CITY OF ALBUQUERQUE

RE: Homewood Suites - 5400 San Antonio Dr. NE
Grading and Drainage Plan
Engineer's Stamp Date 3/16/2018
Hydrology File: E18D050

Based on the information provided in the submittal received on 2/20/17 the above-referenced Grading and Drainage Plan cannot be approved for Site Plan for Building Permit and Building Permit until the following comments are addressed.

C1.1

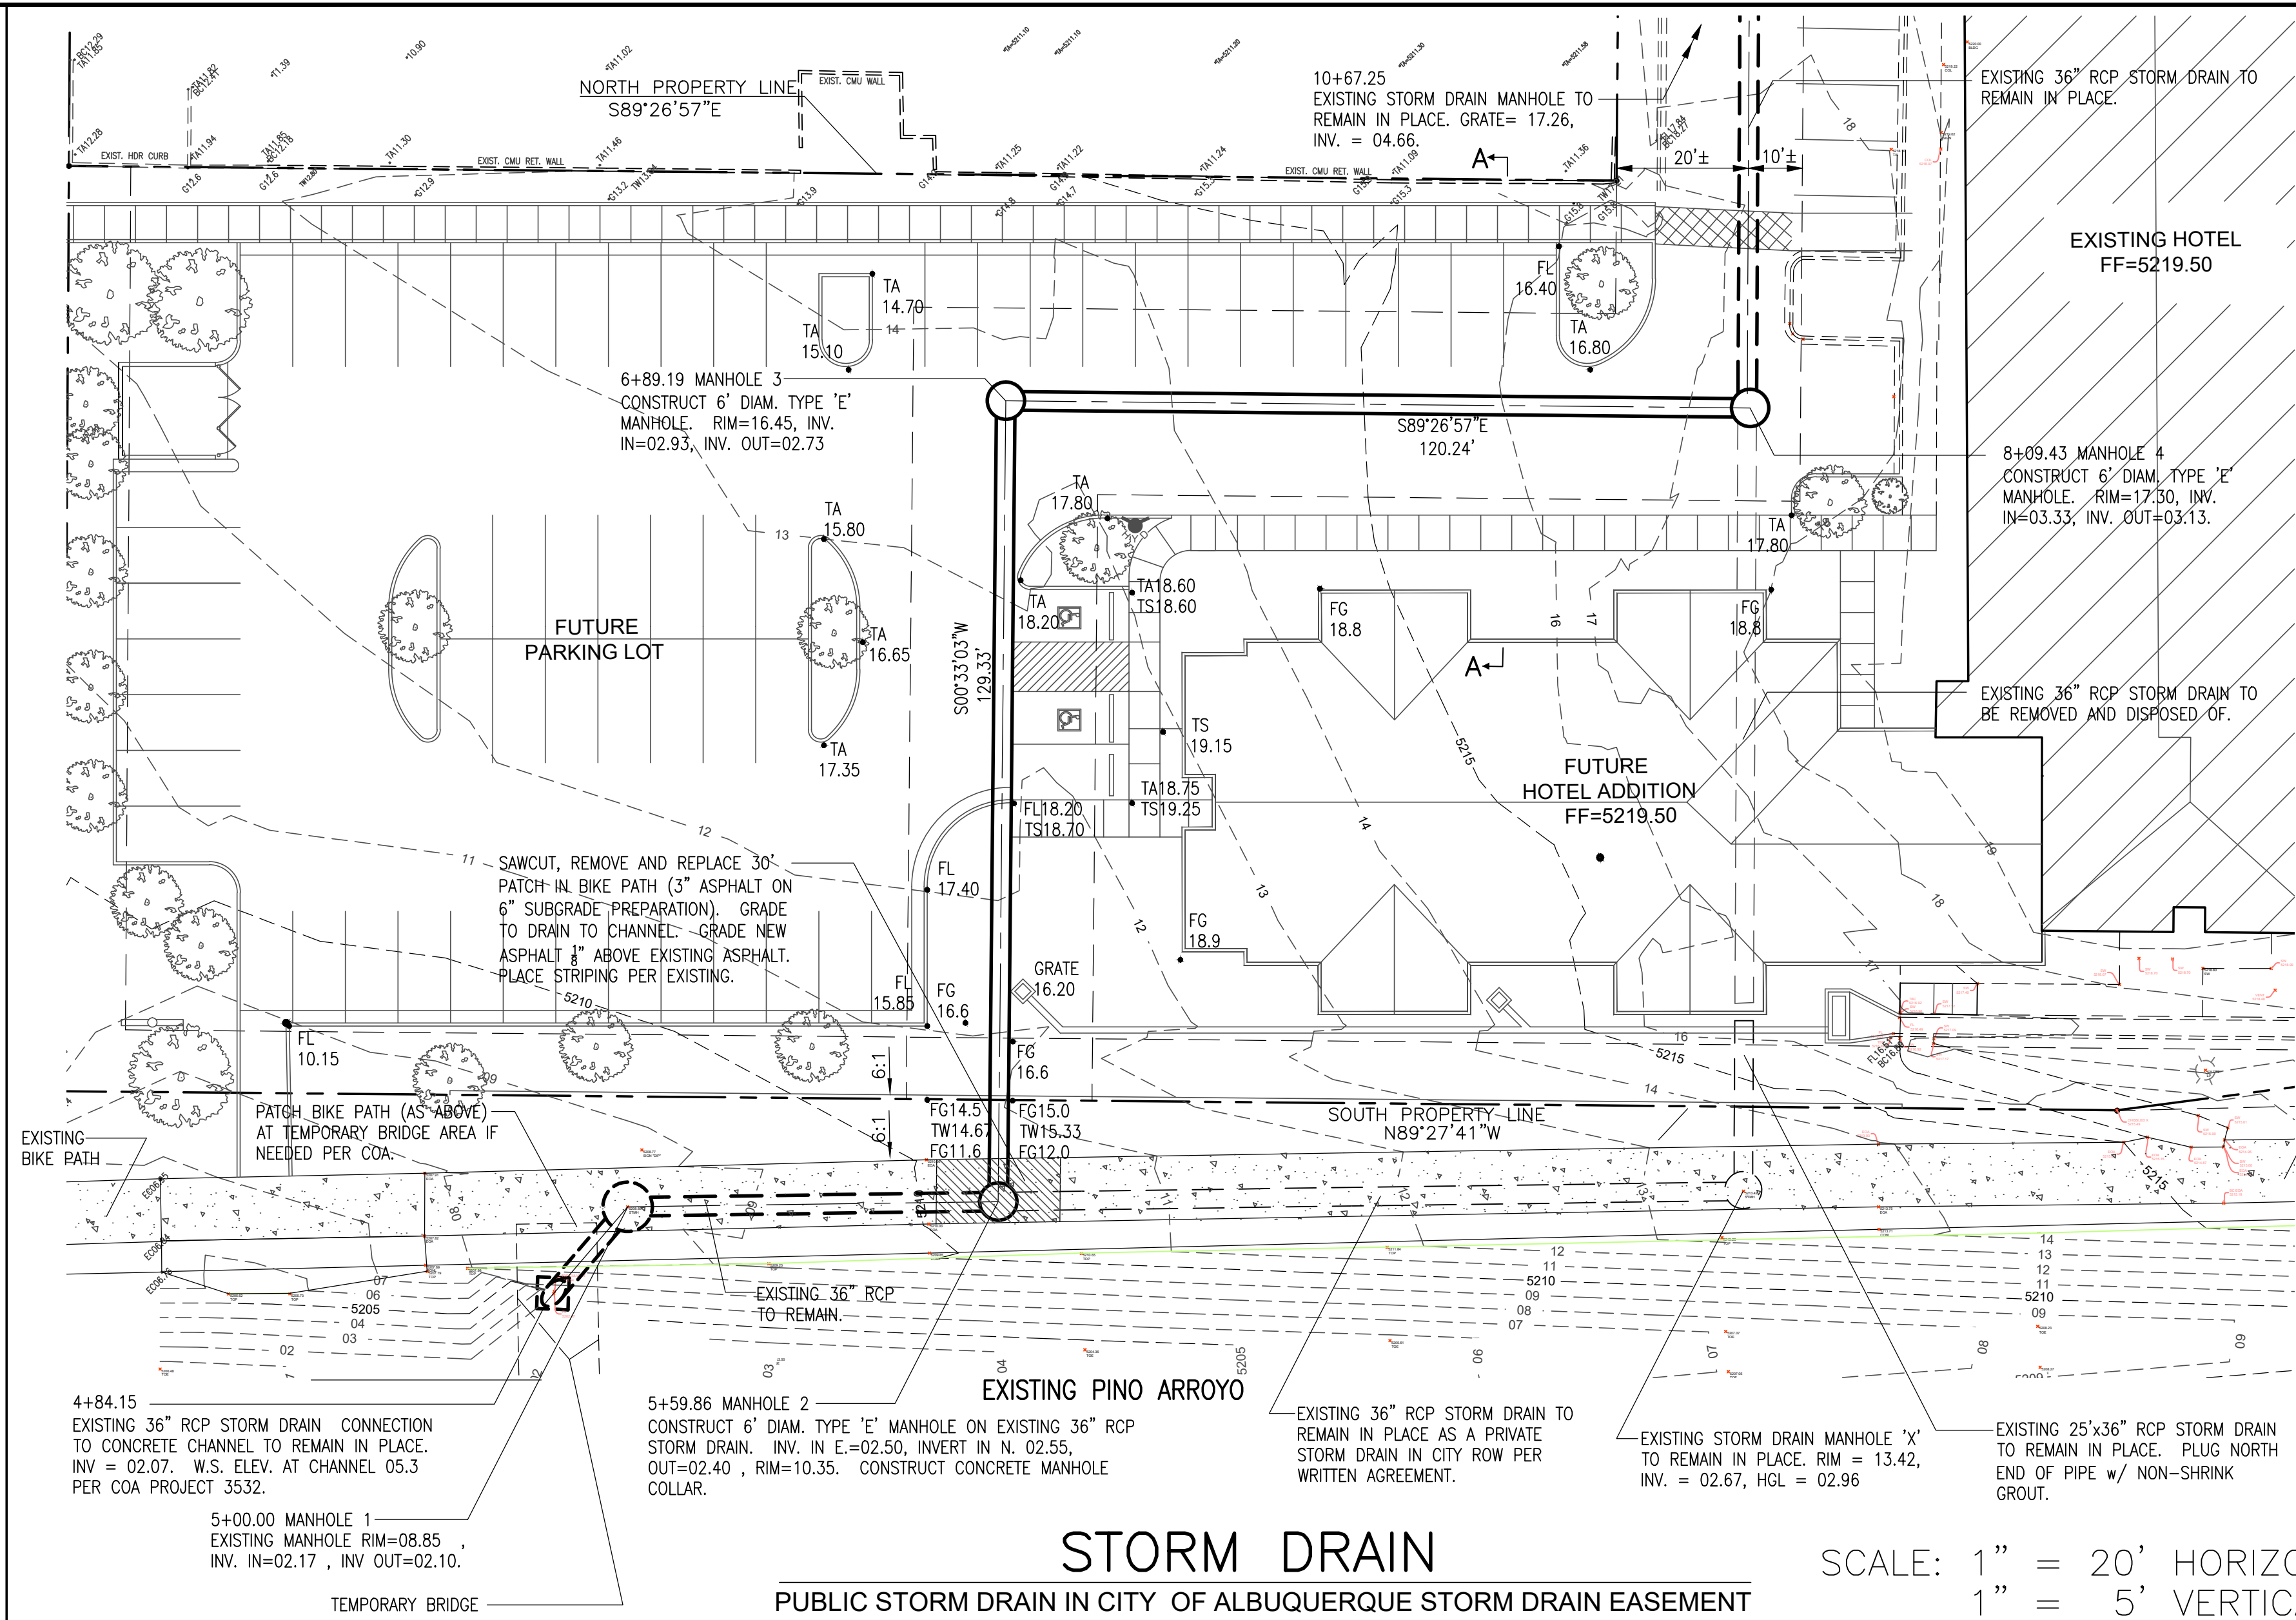
1. As agreed at our meeting several months ago, notes are to be added to the G&D Plan stating that "The existing Public Storm Drain thru this site must remain functional at all times until the new storm drain is constructed. Temporary diversion ditches will be constructed and maintained when the storm drain is not in service".
2. A sheet should be added to the G&D Plan showing the entire area of disturbance including the staging area south of the South Pino Arroyo. The sheet should include a line indicating the limits of disturbance, a note identifying the area of disturbance, and a note requiring "Native seed and mulch per COA STD Spec 1007 (or approved equal) of all disturbed areas prior to Certificate of Occupancy.

NOTE:
THE EXISTING PUBLIC STORM DRAIN THROUGH THIS SITE MUST REMAIN FUNCTIONAL AT ALL TIMES. TEMPORARY DIVERSION DITCHES WILL BE CONSTRUCTED AND MAINTAINED WHEN THE STORM DRAIN IS NOT IN SERVICE.

TITLE
HOMWOOD SUITES
STORM DRAIN PLAN & PROFILE

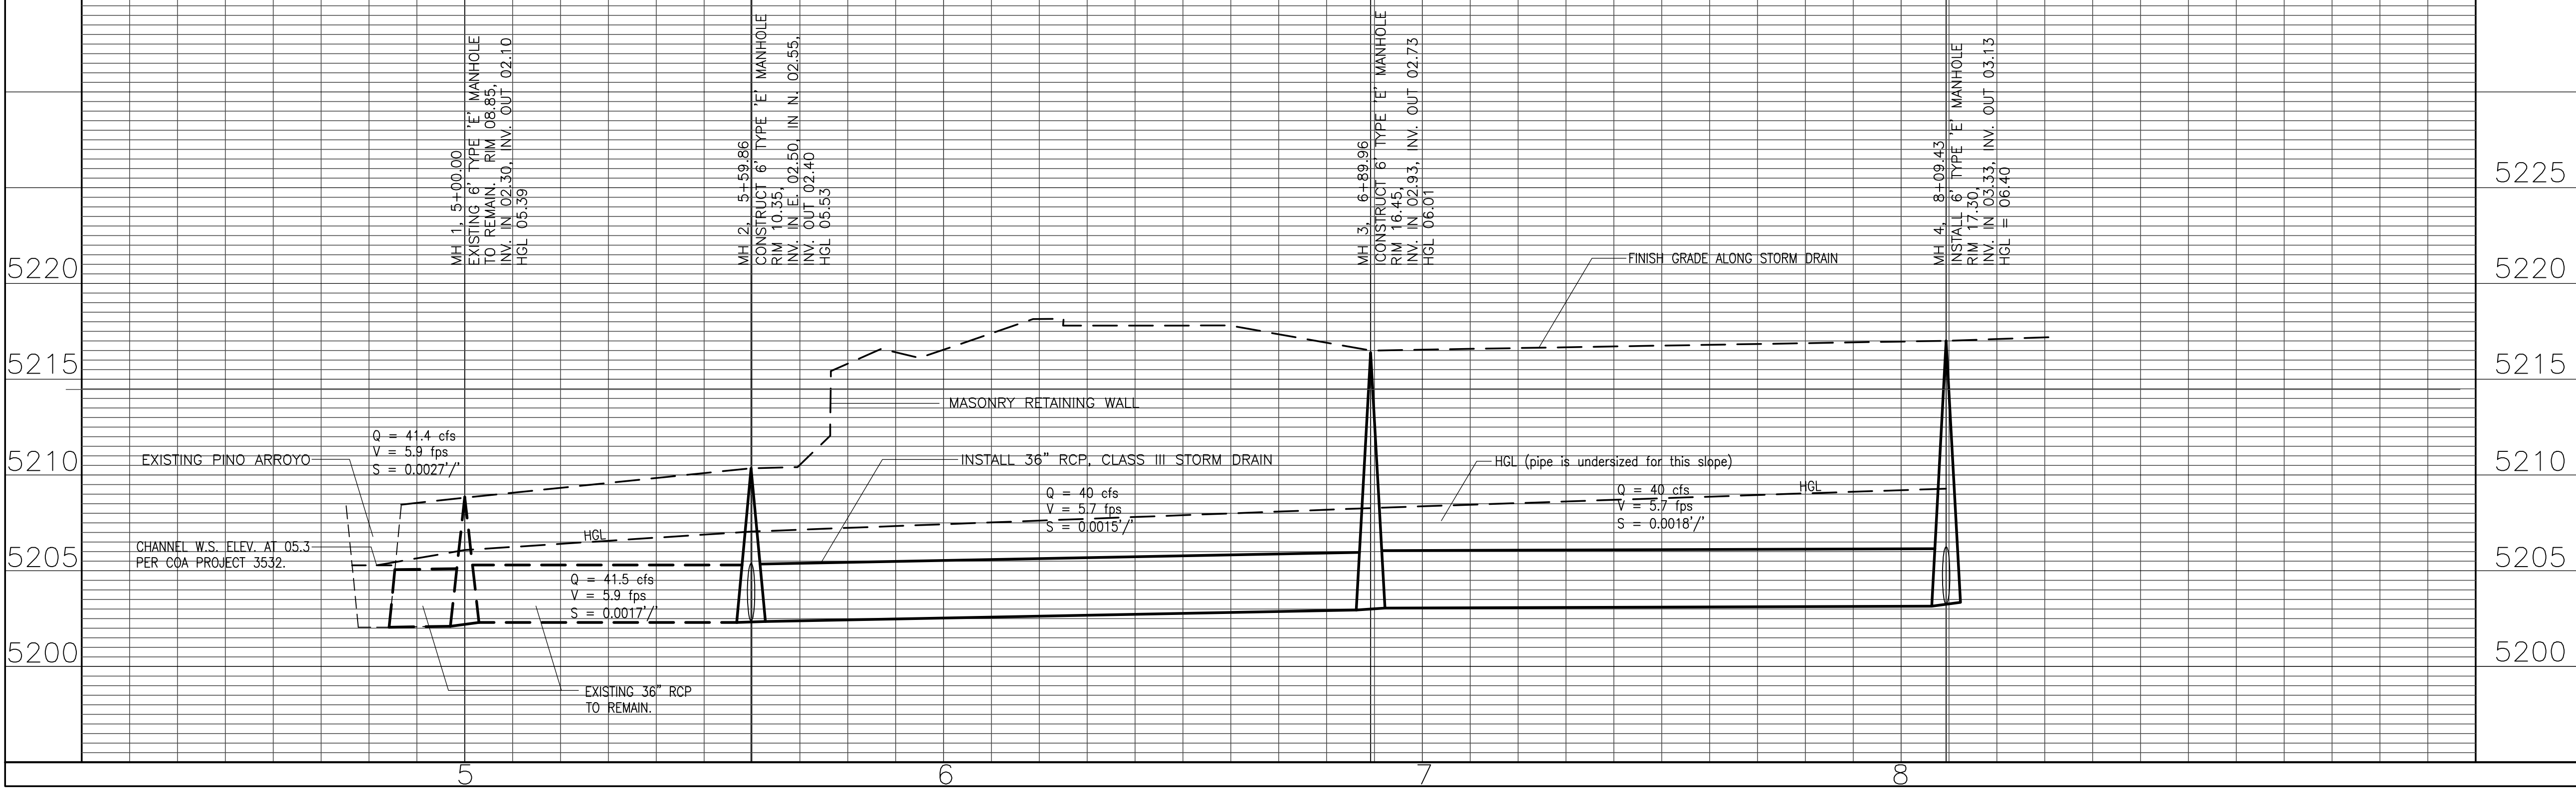
3. Add note 1 above to the DRC Plan & Profile sheet.
4. Remove the note on the plan & profile sheet that says "pipe is undersized..."
